APPENDIX R - ALTERNATIVES

April 2017 FAA SRM Meeting Report and Findings

Minot International Airport - Taxiway B Design Discussion

April 5, 2017

TW Bravo Option 1

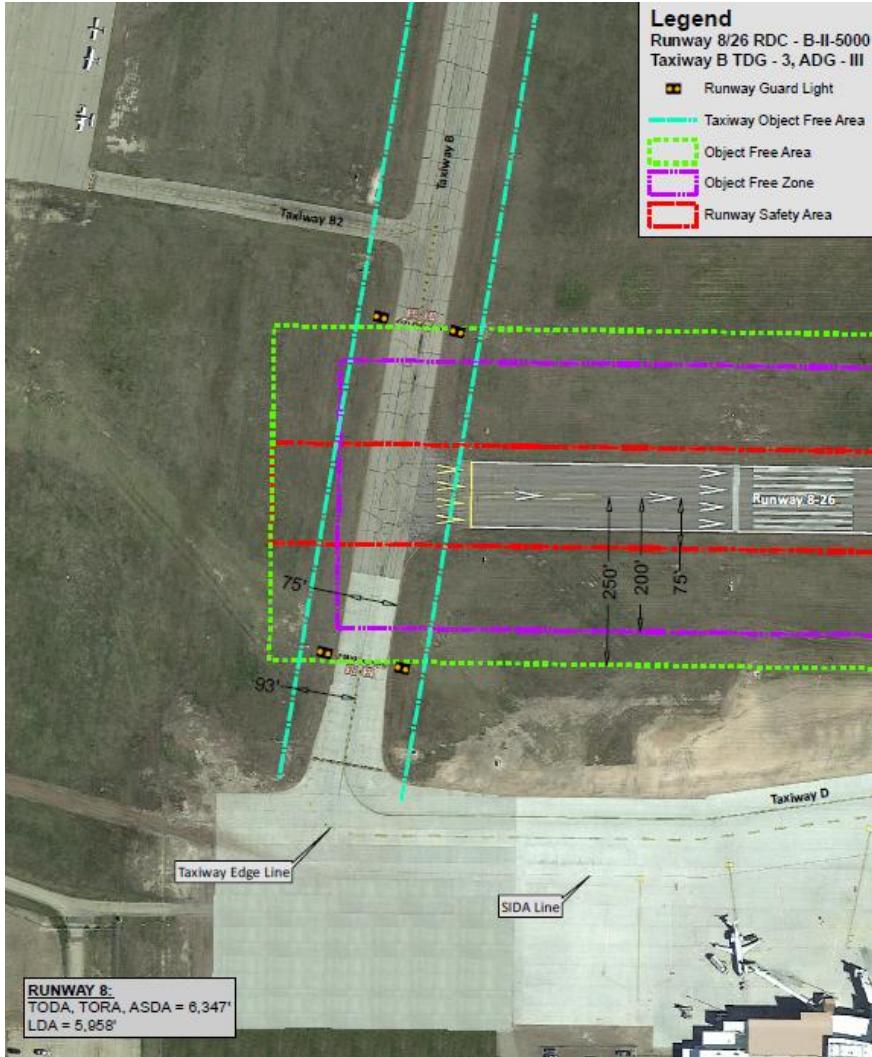
- FAA Design Standards**
 - Aligned Taxiway
- Increased Safety/Hot Spot Mitigation**
 - Better Visibility
 - No Runway Crossing
- Operational Efficiency**
 - TW Routes Maintained
 - No Impact to Ramp Operations
- Cost - \$58,025**

TW Bravo Option 2

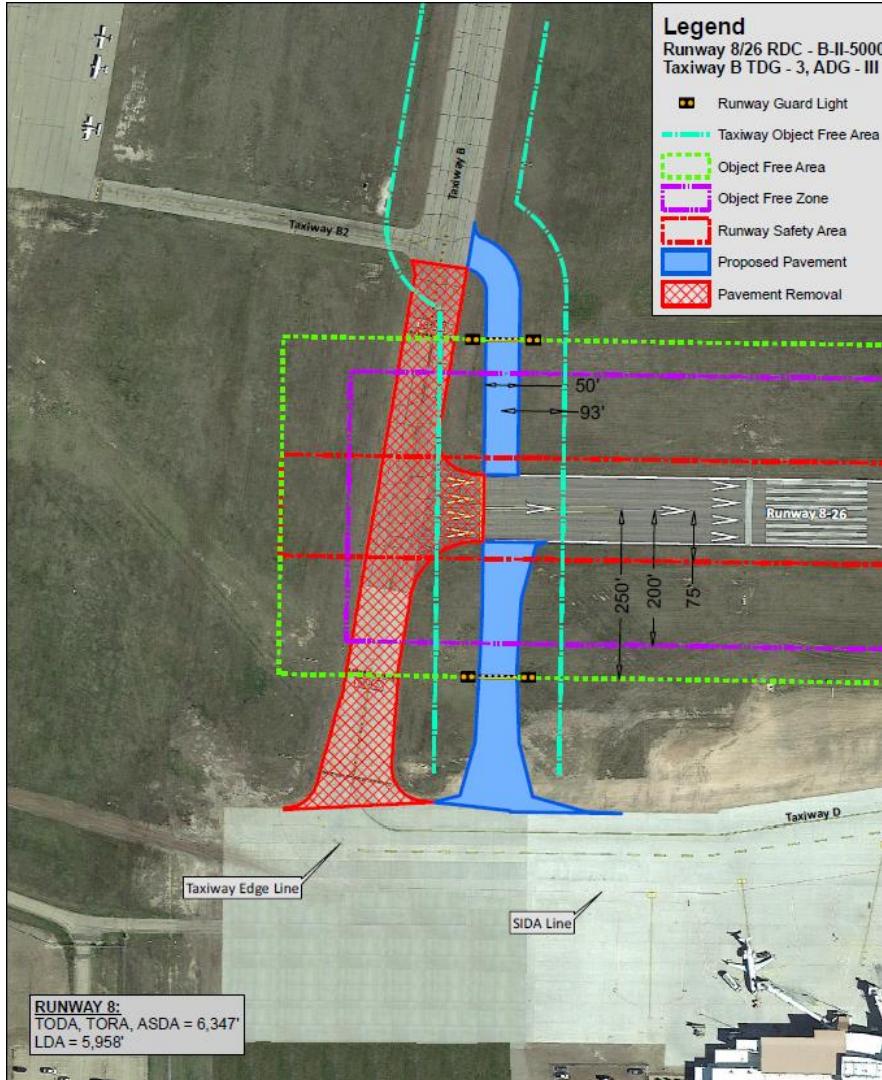
- ✖ **FAA Design Standards**
 - Direct Access
- ✖ **Increased Safety/Hot Spot Mitigation**
 - Loss of Situational Awareness from Ramp
 - Creates Runway Crossing
- ✖ **Operational Efficiency**
 - Potential for Congested Ramp Operations (250' closer)
- **Cost - \$755,000**

TW Bravo Option 2 Large

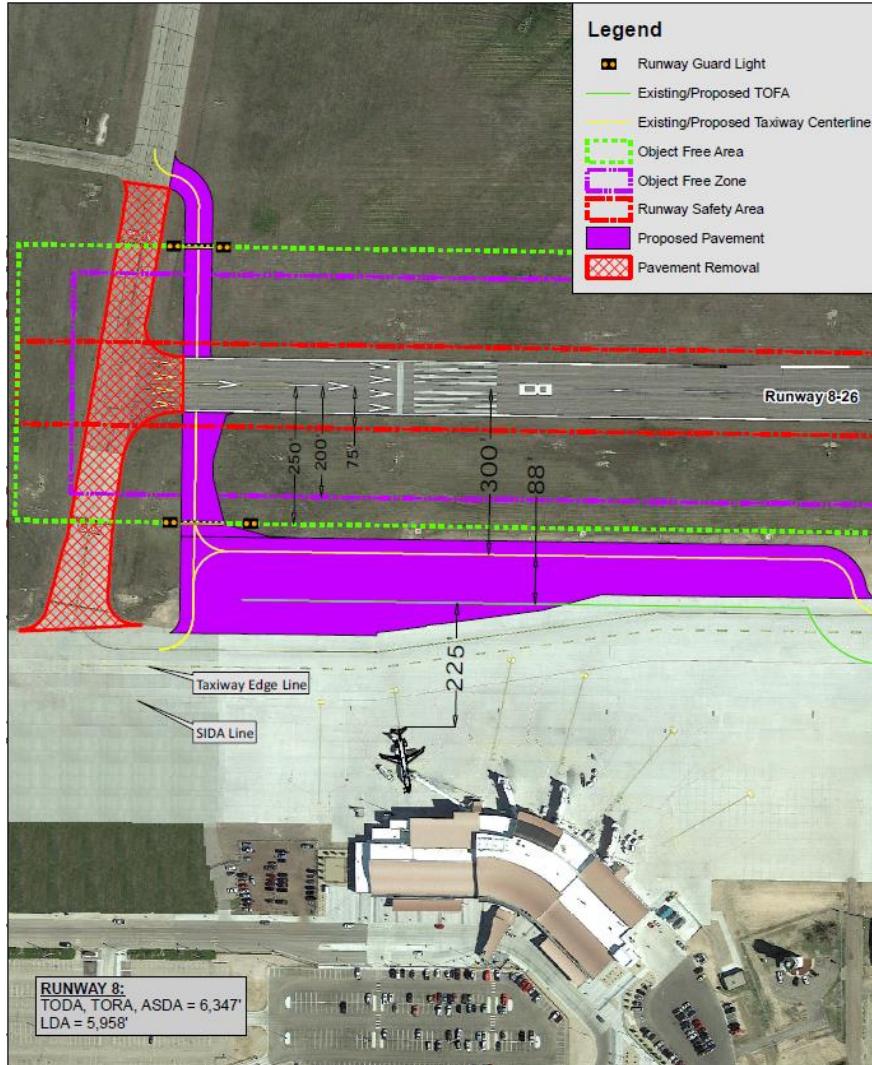
- ✖ **FAA Design Standards**
 - Direct Access
- ✖ **Increased Safety/Hot Spot Mitigation**
 - Potential Loss of Situational Awareness
 - Creates Runway Crossing
- **Operational Efficiency**
 - Allows Greater Maneuverability on Ramp

TW Bravo Option 2 Small

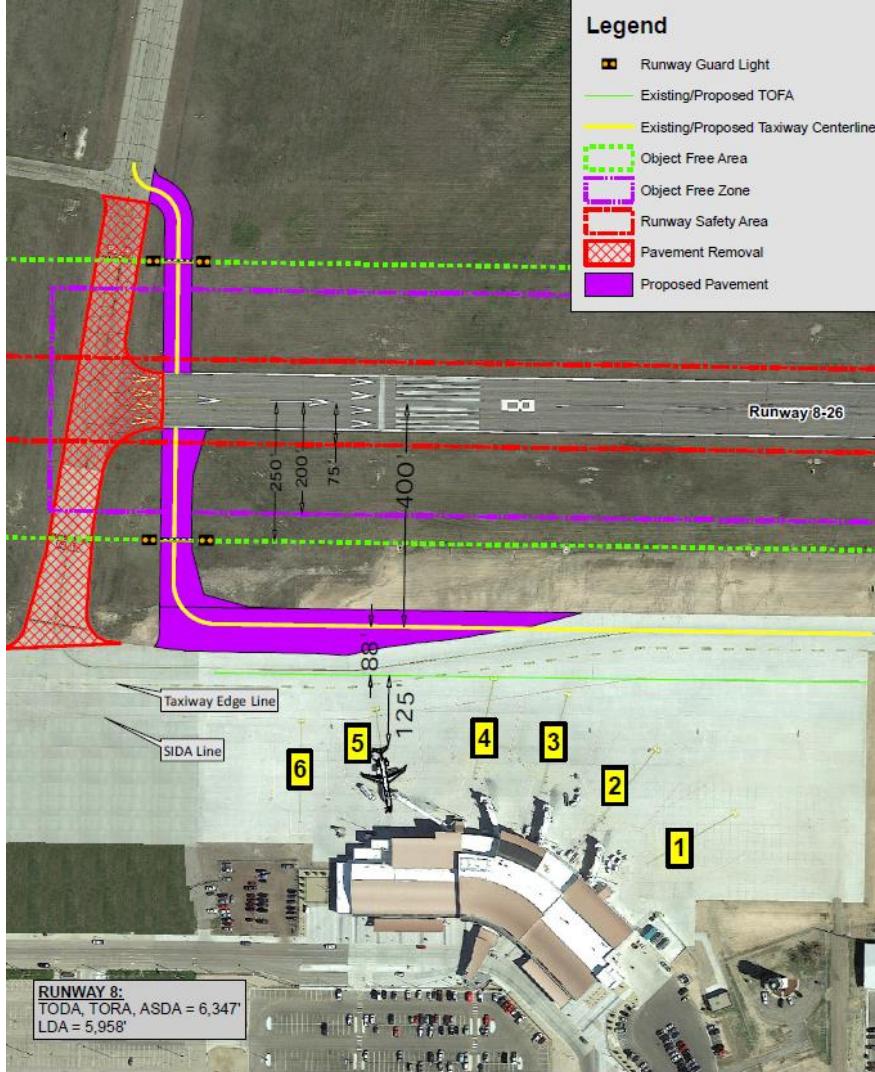
- ✖ **FAA Design Standards**
 - Direct Access
- ✖ **Increased Safety/Hot Spot Mitigation**
 - Potential Loss of Situational Awareness
 - Creates Runway Crossing
- **Operational Efficiency**
 - Allows Some Maneuverability on Ramp

TW Bravo Option 2b (FAA)

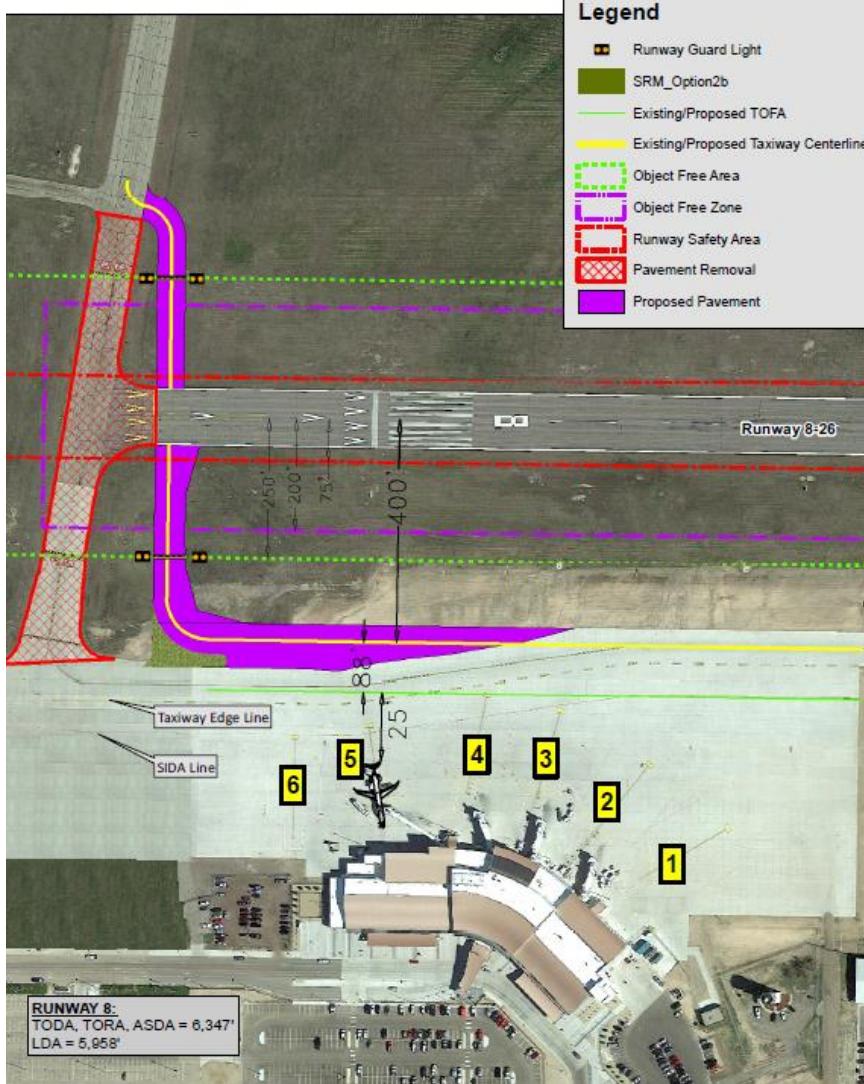
- **FAA Design Standards**
 - No Direct Access
- ✖ **Increased Safety/Hot Spot Mitigation**
 - Creates Runway Crossing
 - Head On Opposing Aircraft Taxiing
- ✖ **Operational Efficiency**
 - Congested Ramp Operations
 - Turn from West

TW Bravo Option 3

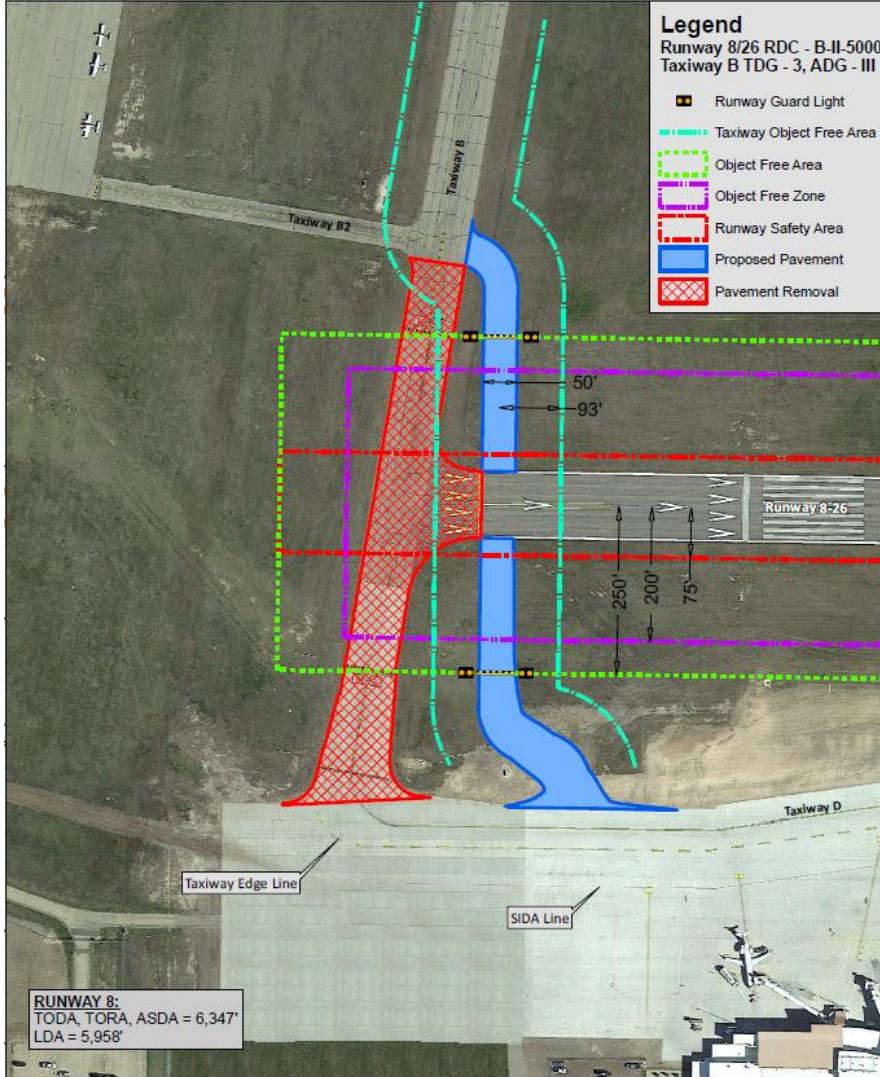
- **FAA Design Standards**
 - No Direct Access
 - No Aligned TW
- ✖ **Increased Safety/Hot Spot Mitigation**
 - Creates Runway Crossing
- ✖ **Operational Efficiency**
 - Congested Ramp Operations (380' Closer)
- **Cost - \$910,800**

TW Bravo Option 3 Large

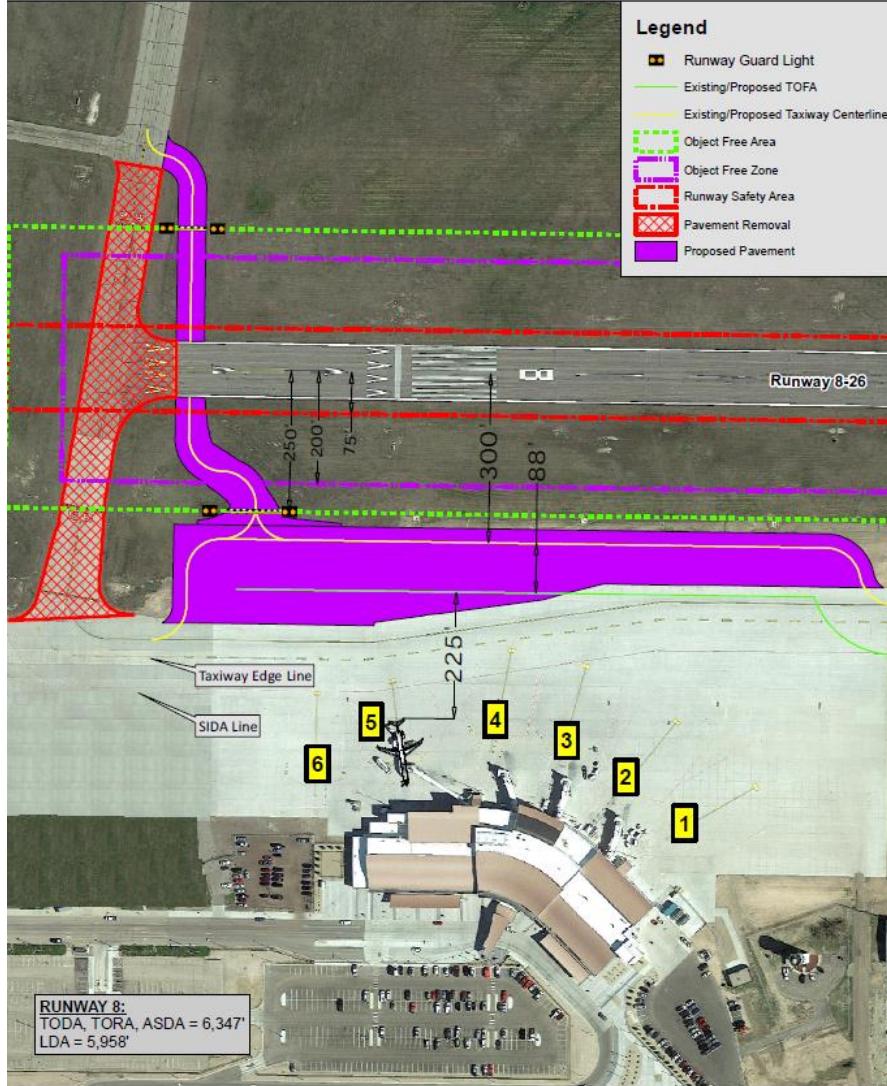
- **FAA Design Standards**
 - No Direct Access
 - No Aligned TW
- ✖ **Increased Safety/Hot Spot Mitigation**
 - Creates Runway Crossing
 - Potential Bottlenecking?
- **Operational Efficiency**
 - Allows Greater Maneuverability on Ramp

TW Bravo Option 3 Small

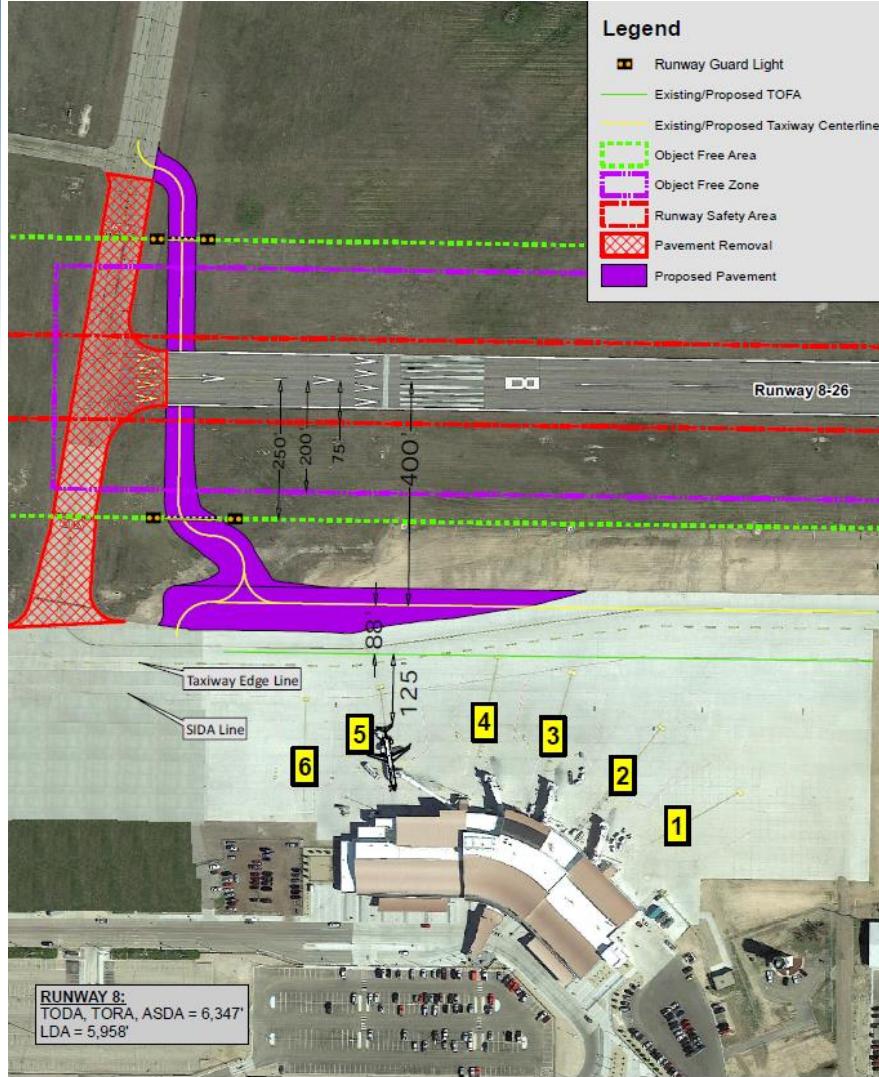
- **FAA Design Standards**
 - No Direct Access
 - No Aligned TW
- ✖ **Increased Safety/Hot Spot Mitigation**
 - Creates Runway Crossing
- **Operational Efficiency**
 - Allows Some Maneuverability on Ramp

TW Bravo Option 4 with RPZ

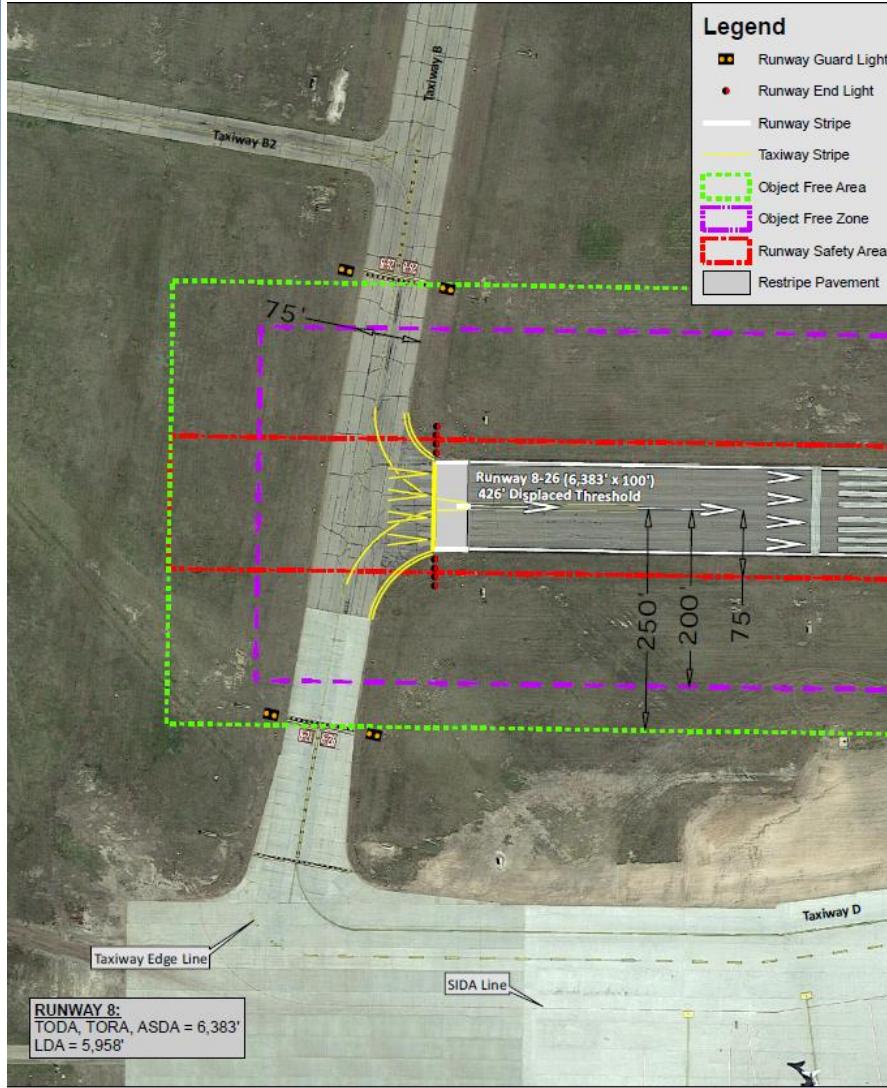
- ☒ **FAA Design Standards**
 - Aligned Taxiway
 - Non-Perpendicular
- **Increased Safety/Hot Spot**
Mitigation
 - Better Visibility
 - No Runway Crossing
- **Operational Efficiency**
 - TW Routes Maintained
 - No Impact to Ramp Operations
- **Cost - \$128,495**

TW Bravo Option 4b with RPZ

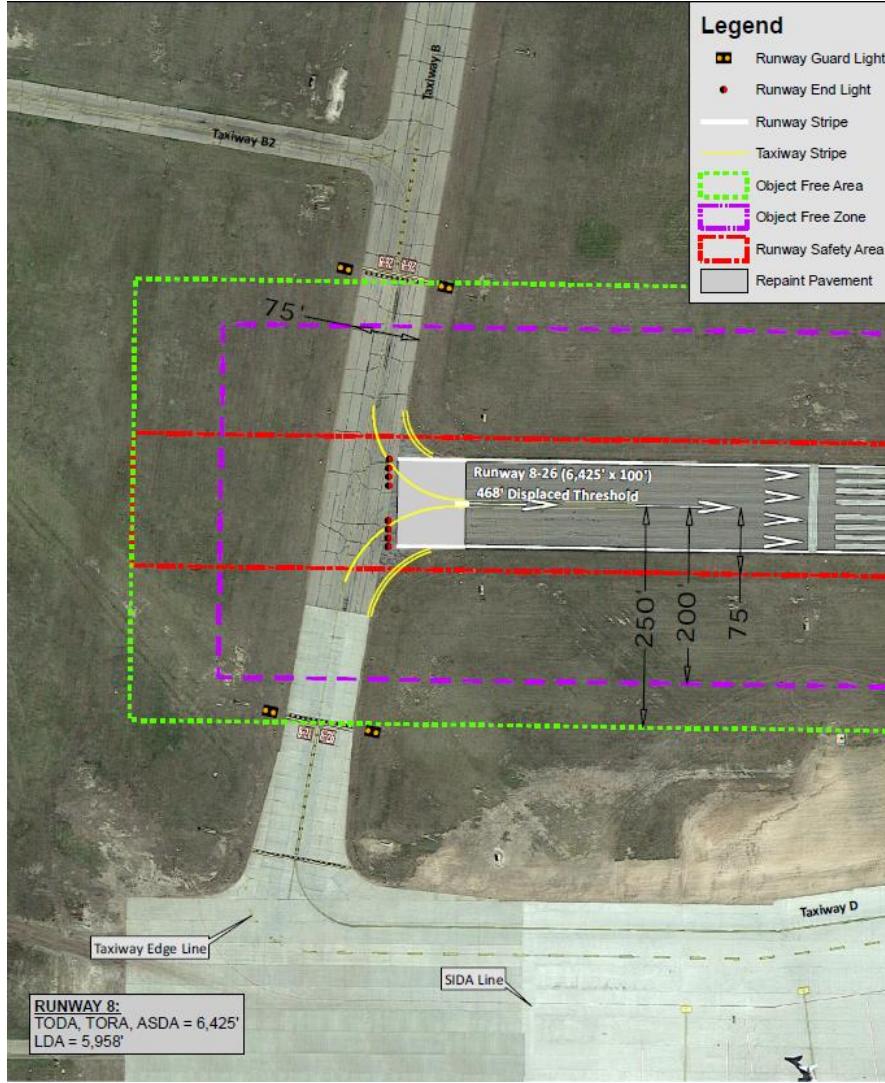
- ☒ **FAA Design Standards**
 - Aligned Taxiway
 - Non-Perpendicular
- **Increased Safety/Hot Spot Mitigation**
 - Better Visibility
 - No Runway Crossing
- **Operational Efficiency**
 - TW Routes Maintained
 - No Impact to Ramp Operations
- **Cost - \$135,495**
